MEETING MINUTES

Project: Governor Printz Interceptors, Section I
New Castle County Project No. 2010-01/220612

Purpose: Geotechnical Meeting

Photo 1 - Stoney Creek Pump Station
March 2, 2011

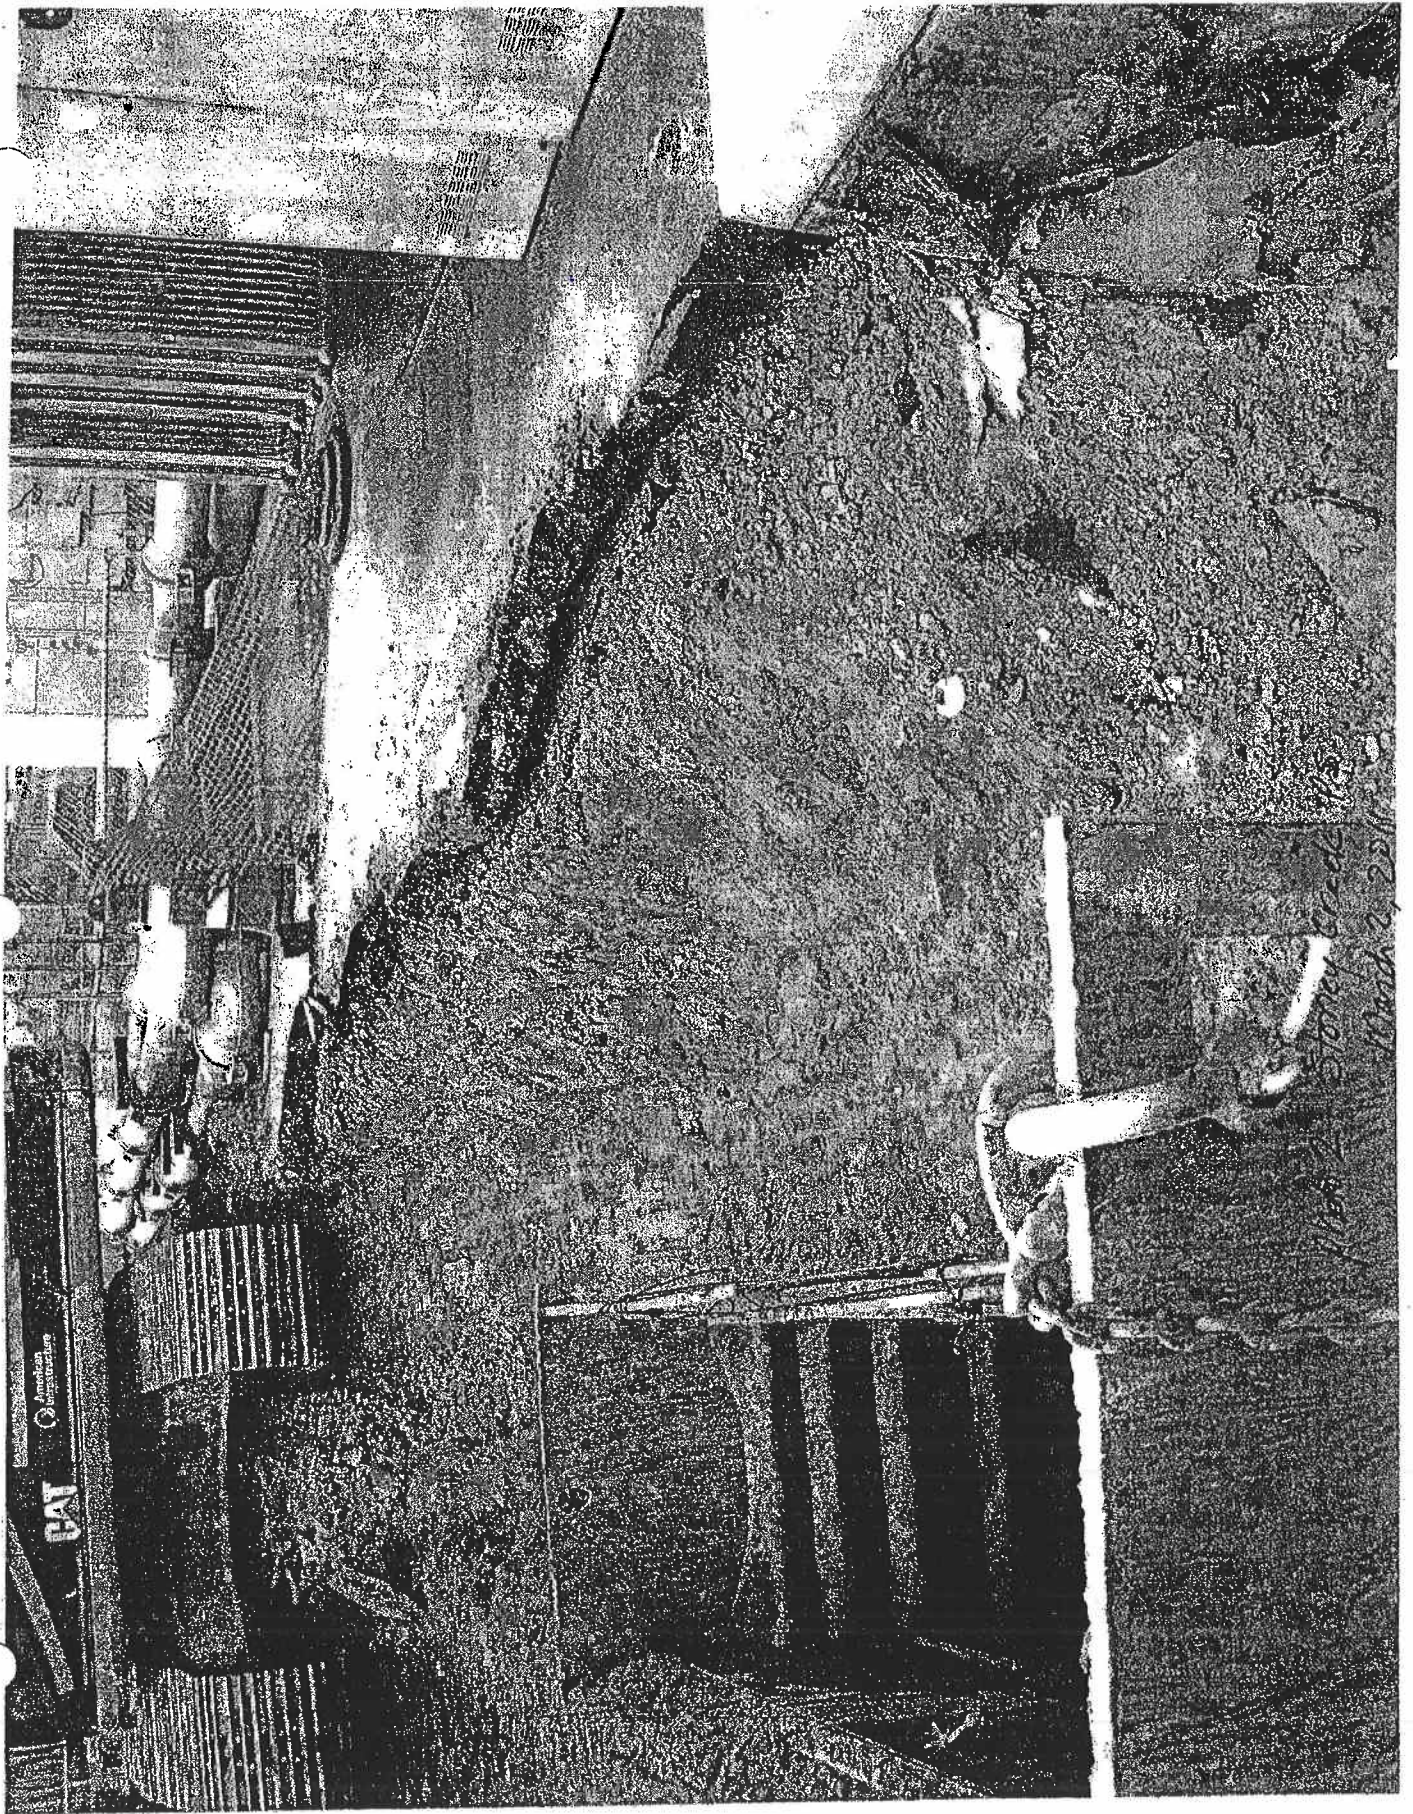
2. PB provided copies of photographs of AAM's trench excavation for the 36 inch interceptor taken at Stoney Creek pump station on March 2 (see attachment). The photos showed earth disturbance under the existing pavement adjacent to the trench box. PB raised concern about the potential for similar settlement under the 6-inch oxygen and nitrogen gas lines and the 24-inch natural gas line adjacent to the trench along Governor Printz Boulevard. Given the weight of the trench box and the compacted fill and the soil friction along the trench box walls, PB found it difficult to envision how AAM could remove the trench box without disturbing the compaction of the backfill and/or causing settlement outside of the trench box. PB suggested (again) that AAM install geotechnical instrumentation monitoring at the pump station in order to prove that AAM's means and methods
